# Exhibit 13: Northwest Branch Option B

### C. TRANSPORTATION MODIFICATIONS

#### 1. US 29 INTERCHANGE

# Exhibit 16: US 29 Interchanges in DEIS

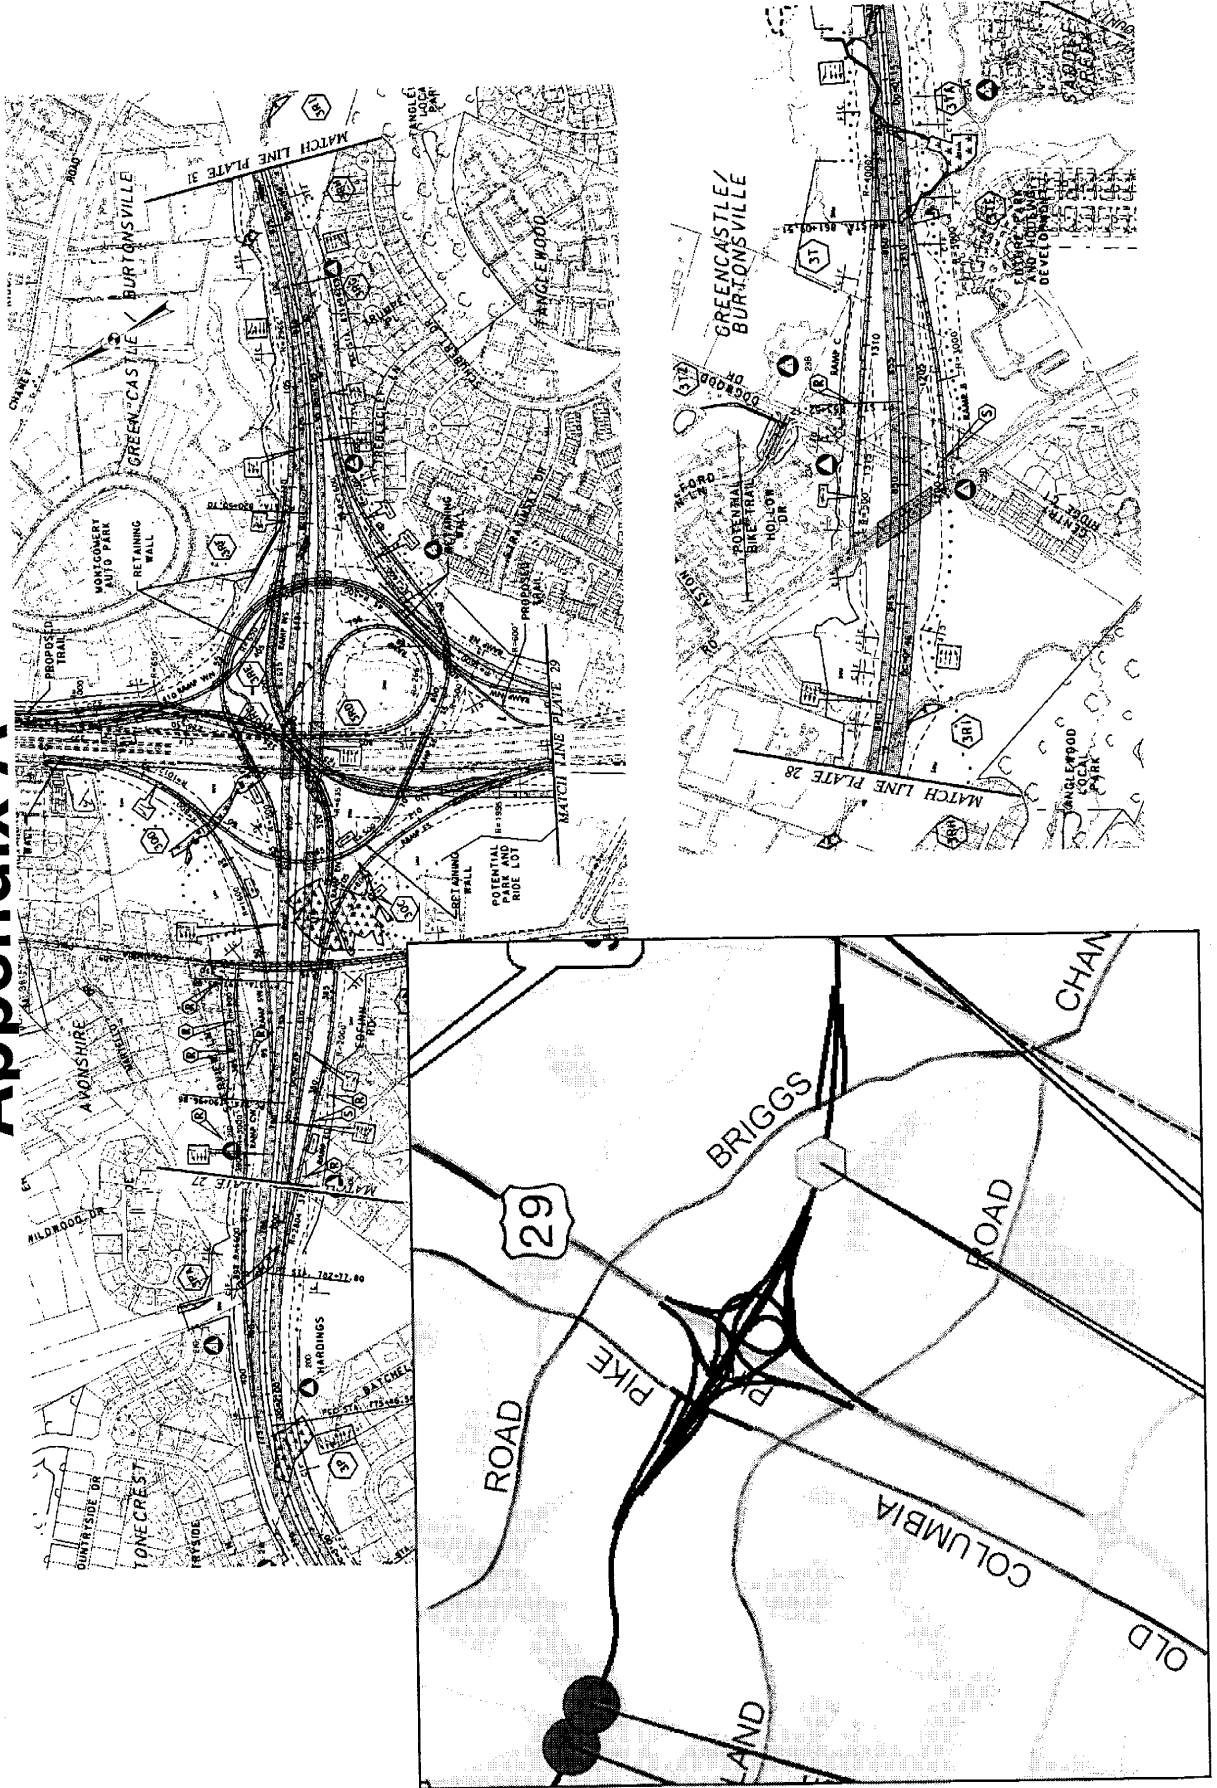
The DEIS design of the US 29 interchange includes additional, non-master-planned ramps as the ICC crosses Old Columbia Pike and Briggs Chaney Road. The ramp configuration is described as a "split diamond" configuration, because the access to the ICC is split between ramps to and from the west only at Old Columbia Pike and ramps to and from the east only at Briggs Chaney Road. The interchange concept is shown schematically in Exhibit 15 and a mosaic of DEIS Appendix A plates 27 through 31 is shown in Exhibit 16.

The DEIS does not specifically analyze the travel demand effects of removing individual ramps in the US 29 interchange complex. Working in conjunction with the ICC study team, however, staff estimates that in 2030 approximately 11,000 vehicles per day would use the Old Columbia Pike ramps and approximately 15,000 vehicles per day would use the Briggs Chaney Road ramps. If either set of ramps were removed, some of the traffic that would benefit from the ramps would still use those local roads to access the ICC via those ICC-access movements allowed at Briggs Chaney Road and the Randolph Road interchanges. MDOT analysis suggests that the rerouted local traffic associated with ramp removal may cause the signalized intersection at Briggs Chaney Road and the US 29 northbound ramps to exceed congestion standards. Staff review of the material indicates that the intersection performance would be degraded by the removal of the Briggs Chaney Road ramps (forcing auto park traffic, for instance, west along Briggs Chaney Road through the referenced intersection toward US 29 rather than east toward the ICC). Staff estimates that removing the Old Columbia Pike ramps would have less of an effect on this intersection.

**Staff recommends that the DEIS Corridor 1 interchange at Briggs Chaney Road should be retained in the selected alternative but that DEIS Corridor 1 interchange at Old Columbia Pike should be deleted from the selected alternative.** Staff support for changing the master plan to incorporate an ICC interchange at Briggs Chaney Road but retaining the master plan for no interchange at Old Columbia Pike is based on the following findings:

# Exhibit 17: Master Plan for Interchanges Along US 29

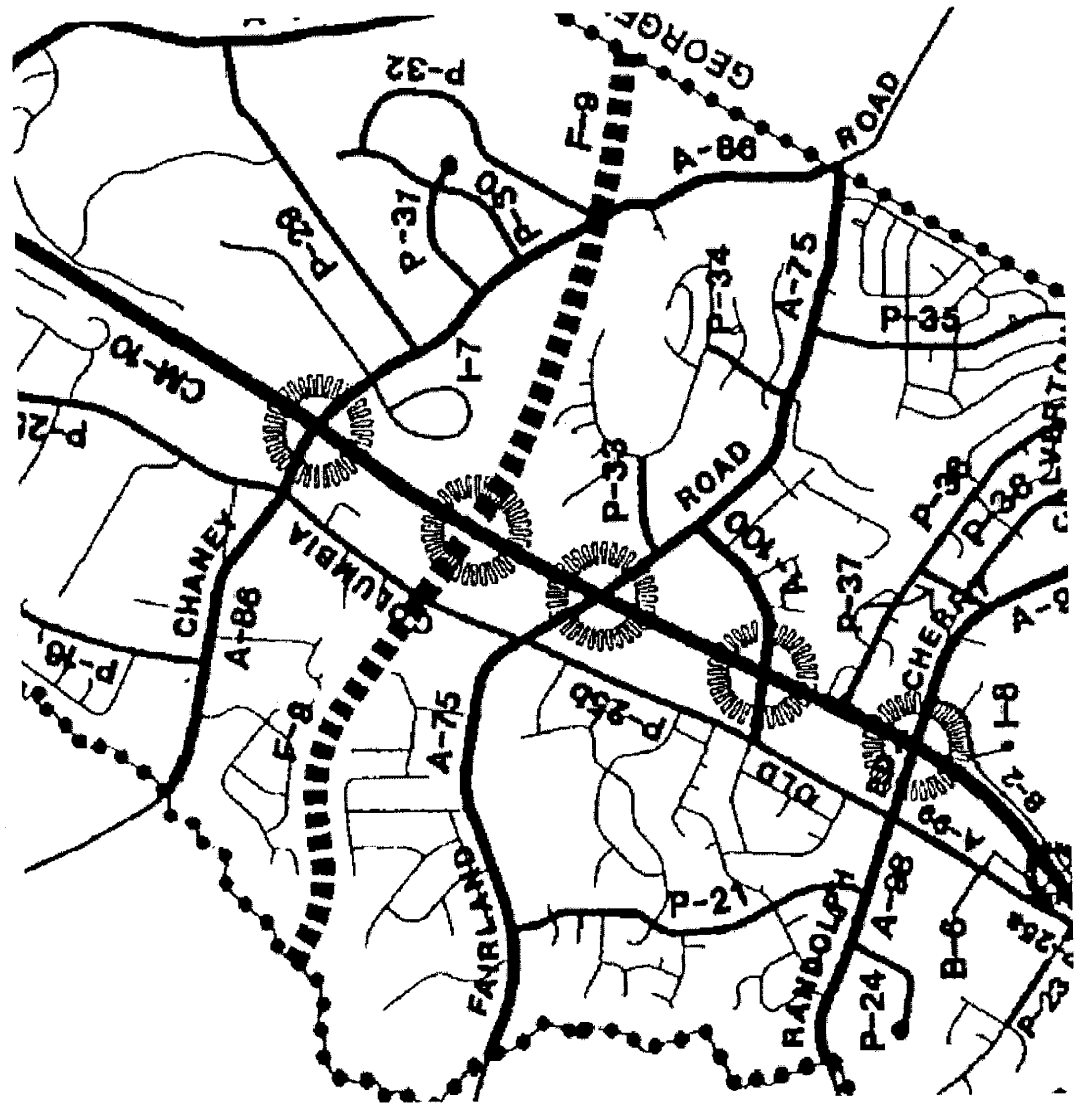
The Fairland Master Plan vision for interchanges along US 29 is shown in Exhibit 17. The Master Plan recommends that ultimately, all at grade intersections (traffic signals and stop signs) be removed from US 29 in the Fairland Master Plan, although the plan does contain a caveat that the interchanges should be phased so that the effects of the first few interchanges can be assessed before proceeding with the remaining interchanges.

# Exhibit 18: MDOT Bike Path Proposal

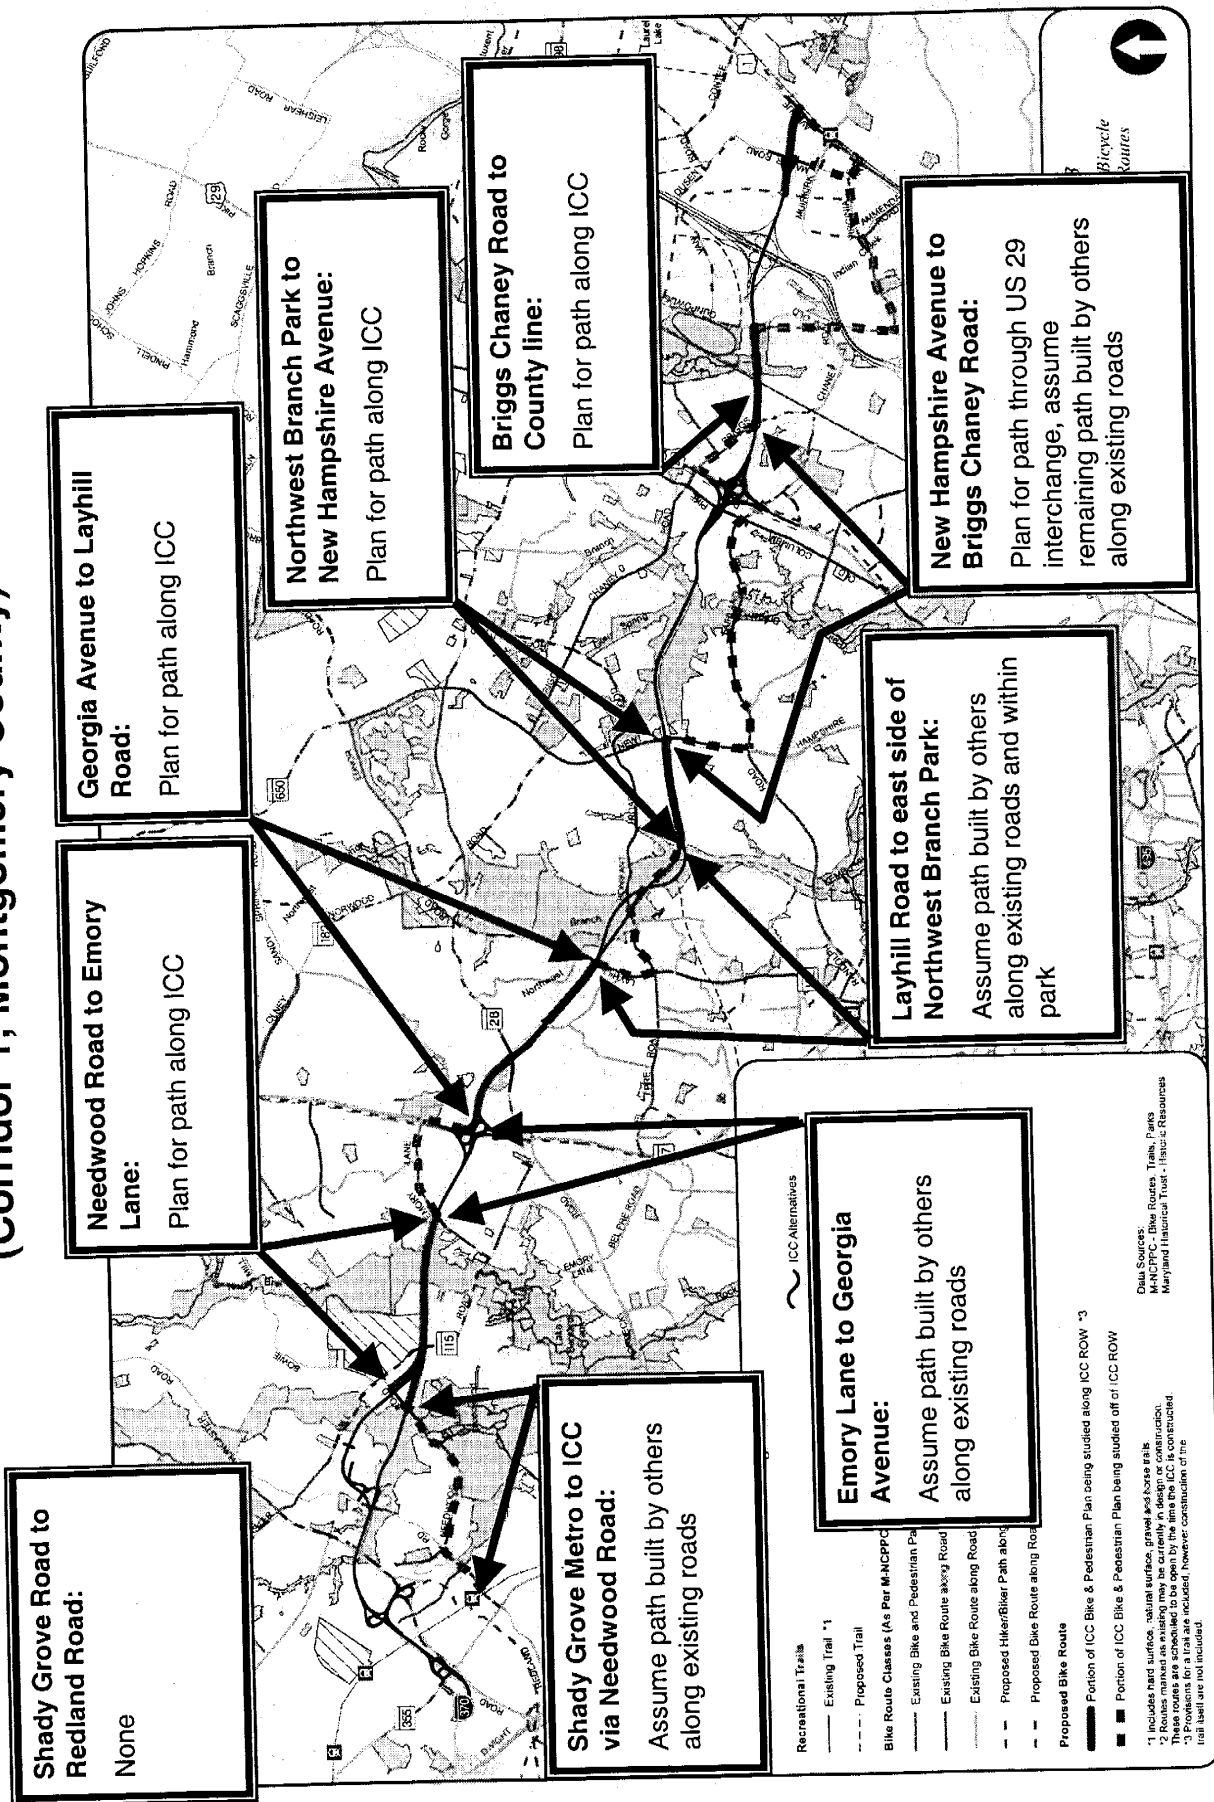
- Physical provisions such as grading and structures, but not paving for sections totaling approximately 7.7 miles along the ICC alignment. This segmentation leaves the following notable gaps:
  - Shady Grove Road to Needwood Road
  - Emory Lane to Georgia Avenue
  - Northwest Branch Park
  - Paint Branch Park
  - Section east of Paint Branch Park to Briggs Chaney Road
- Reliance on future bikeways to be provided by others on parallel roads for network connectivity.

None of these concerns were adequately addressed in the DEIS. Subsequent to DEIS publication, MDOT provided partial information on the incremental capital costs and natural environmental impacts of constructing the 7.7-mile series of segments as described in the staff's January 7, 2005 memorandum to the Planning Board. MDOT has not provided substantive justification for their decision to abandon the remainder of the shared-use path.

As previously described, the DEIS concept deviates significantly from the ICC alignment in five areas. Staff suggests that the deviations described above can appropriately satisfy the intent of the Countywide Park Trails Plan and the Countywide Bikeways Functional Master Plan. Staff believes MDOT should amend their concept for two of the sections, however, as described below:

- **Shady Grove Road to Needwood Road:** The SHA proposal to connect to the Shady Grove Metrorail station via Needwood and Redland Roads is logical. However, the abandonment of the shared-use path extension along M-83 creates a significant gap in the shared-use path network between Olney and Gaithersburg, including paths on Midcounty Highway, Airpark Road, and Woodfield Road. Staff concurs that neither the ICC Option A (due to environmental resources) nor Option C (due to limited right-of-way through the Winters Run community) are appropriate shared-use path extensions for the ICC bike path. Muncaster Mill Road (MD 115) provides the most logical connection for the shared-use path.

- **Emory Lane to Georgia Avenue:** SHA staff has indicated that the proposal to route the ICC bike path along Georgia Avenue and Emory Lane is based primarily on concerns regarding bicyclists crossing Georgia Avenue. Staff finds that such a crossing would not be extraordinarily difficult, as the interchange will have one fully signalized intersection and a second “half-signal” that could be converted to full signalization. The right-of-way and natural resources in the one-mile segment of Corridor 1 between Emory Lane and Georgia Avenue should not present unusually adverse conditions for bike path implementation. Conversely, while the Emory Lane shared-use path is a valuable connection to Olney Manor Recreational Park, it is about a half-mile longer and has many more (estimated at two dozen) driveways and intersections. **Therefore, MDOT should restore this “missing segment” in the ICC bike path concept.**
